Docket No. 50-423 B16514

Millstone Nuclear Power Station Unit No. 3 Proposed Revision to Technical Specification <u>Reactor Trip System Setpoints</u> (PTSCR 3-20-97) <u>Marked Up Page(s)</u>

June 1997

Table 2.2-1 Notes 1 and 3

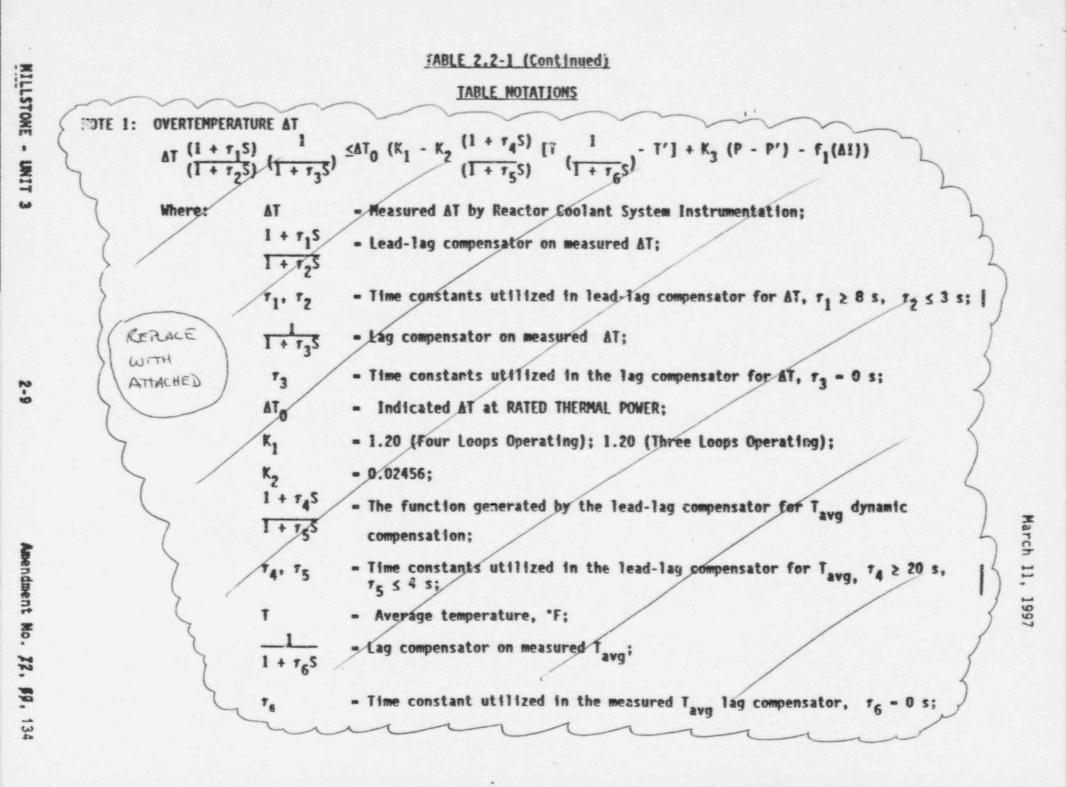
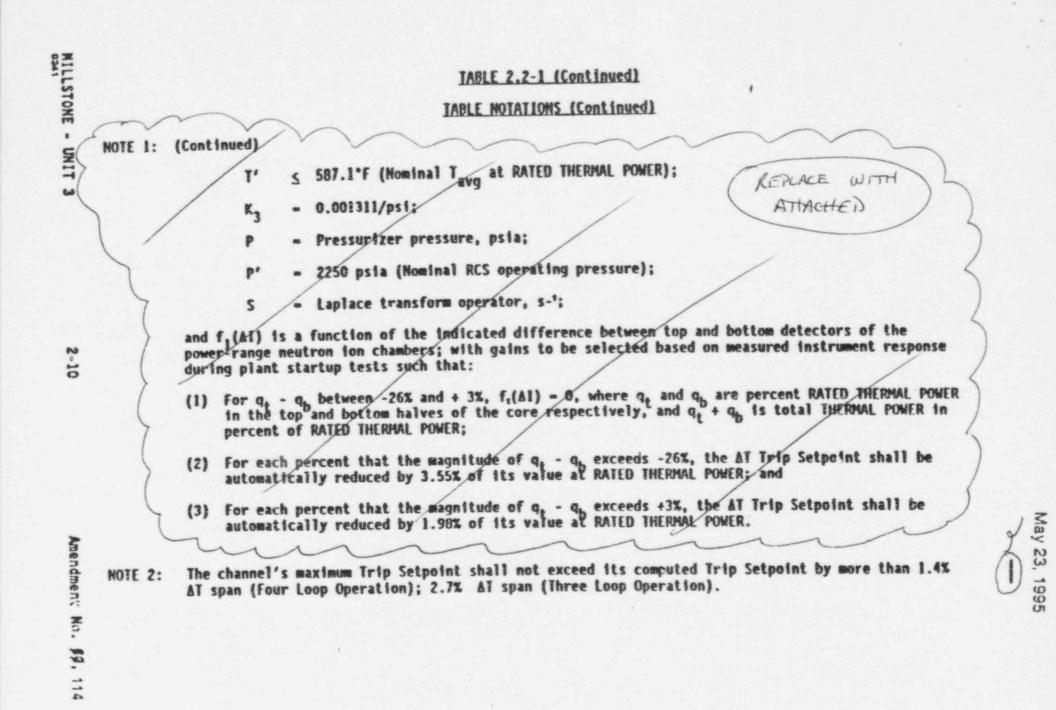
- Tab'a Notations Note 1: Overtemperature ∠T is replaced with the attached. Changes include: Certain function constants are deleted. Loop Specific indicated ∠T relocated to the left side of the algorithm. Constant definitions have been updated with minor wording changes and by changing "=" to "is". Numeric constants redefined using either " ≤" or " ≥"
- Table Notations Note 3: OverPower ⊿T is replaced with the attached. Changes include: Certain function constants are deleted. Loop Specific indicated ⊿T relocated to the left side of the algorithm. Definitions have been updated with minor wording changes and by changing "=" to "is". Numeric constants redefined using either "≤" or "≥"

$$\left(\frac{\Delta T}{\Delta T_0}\right)\frac{(1+\tau_1 s)}{(1+\tau_2 s)} \leq K_1 - K_2 \frac{(1+\tau_4 s)}{(1+\tau_5 s)}(T-T') + K_3(P-P') - f_1(\Delta I)$$

Where: ΔT is measured Reactor Coolant System ΔT , °F;

ΔTo in loop specific indicated ΔT at RATED THERMAL POWER, °F;

$\frac{(1 + \tau_1 s)}{(1 + \tau_2 s)}$ is the function generated by the lead-lag compensator on measured ΔT ;

τ_1 and τ_2 are the time constants utilized in the lead lag compensator for ΔT , $\tau_1 \ge 8$ sec, $\tau_2 \le 3$ sec;

$K_1 \le 1.20$ (Four Loops Operating); ≤ 1.20 (Three Loops Operating);

K₂ ≥ 0.02456/ °F;

$\frac{(l + \tau_4 s)}{(l + \tau_5 s)}$ is the function generated by the lead-lag compensator for T_{avg} ;

τ_4 and τ_5 are the time constants utilized in the lead-lag compensator for T_{avg} , $\tau_4 \ge 20$ sec, $\tau_5 \le 4$ sec;

T is measured Reactor Coolant System average temperature, °F;

T' is loop specific indicated Tavg at RATED THERMAL POWER, ≤ 587.1°F;

K₃ ≥ 0.001311/ psi

P is measured pressurizer pressure, psia;

P' is nominal pressurizer pressure, ≥ 2250 psia;

s is the Laplace transform operator, sec⁻¹;

NOTE 1: (Continued)

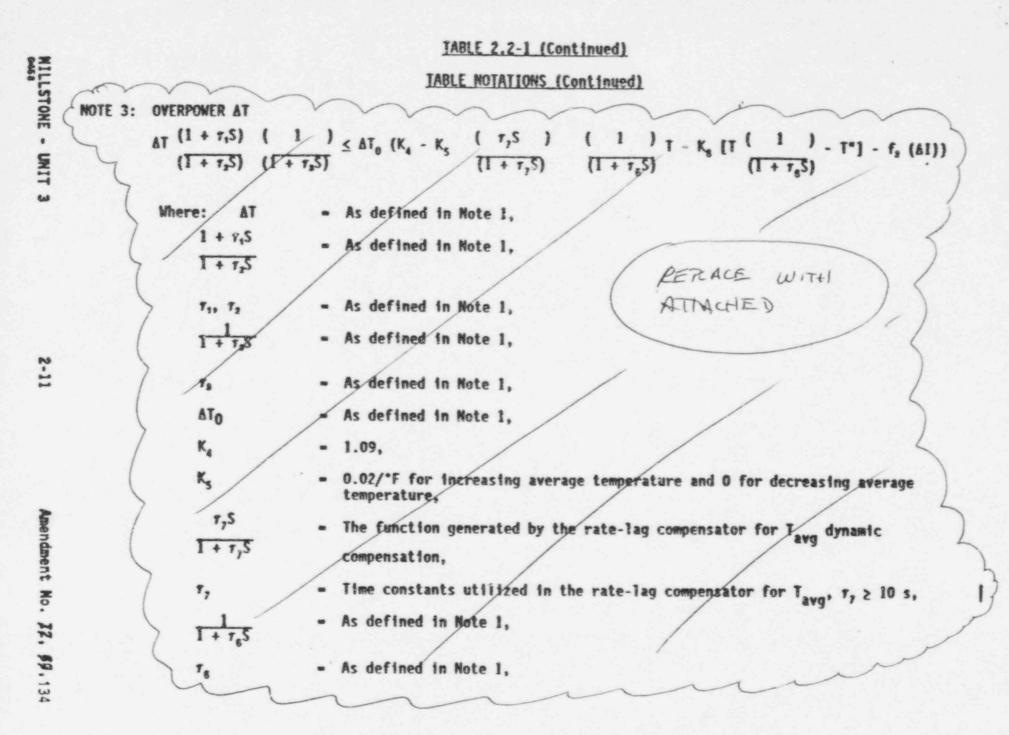
and $f_1(\Delta I)$ is a function of the indicated difference between top and bottom detectors of the power range neutron ion chambers; with nominal gains to be selected based on measured instrument response during plant startup tests calibrations such that:

- (1) For q_t q_b between -26% and + 3%, f₁(ΔI) ≥ 0, where q_t and q_b are percent RATED THERMAL POWER in the upper and lower halves of the core, respectively, and q_t + q_b is the total THERMAL POWER in percent RATED THERMAL POWER;
- (2) For each percent that the magnitude of qt qb exceeds -26%, the ∆T Trip Setpoint shall be automatically reduced by ≥3.55% of its value at RATED THERMAL POWER;
- (3) For each percent that the magnitude of qt qb exceeds +3%, the ∆T Trip Setpoint shall be automatically reduced by ≥1.98% of its value at RATED THERMAL POWER.
